# Product Safety Recall

## 16107 Accelerator Pedal Entrapment

Reference Number: N15201881

Release Date: November 2016  
Revision: 00

4620176

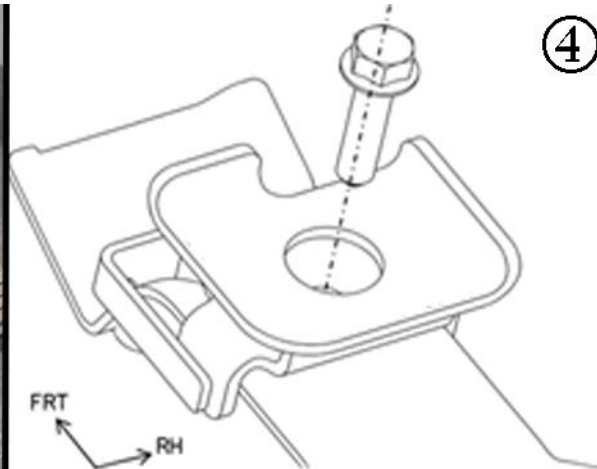
2. Tighten the two accelerator pedal mounting nuts shown above to 18 Nm (13 ft. lb.).

4620177

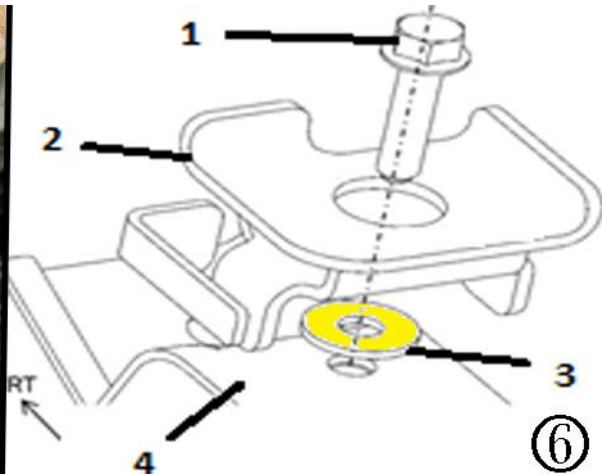
3. Remove the stopper bolt and nut, using 12mm wrench (3). Discard both the old stopper bolt and nut.
4. Temporarily install the new stopper bracket and new stopper bracket mounting bolt (4). When tightened (even by hand), the head of the new mounting bolt should be below the flat surface of the new stopper bracket.

**Note:** Be sure to properly align the new brake stopper bracket as indicated (4).
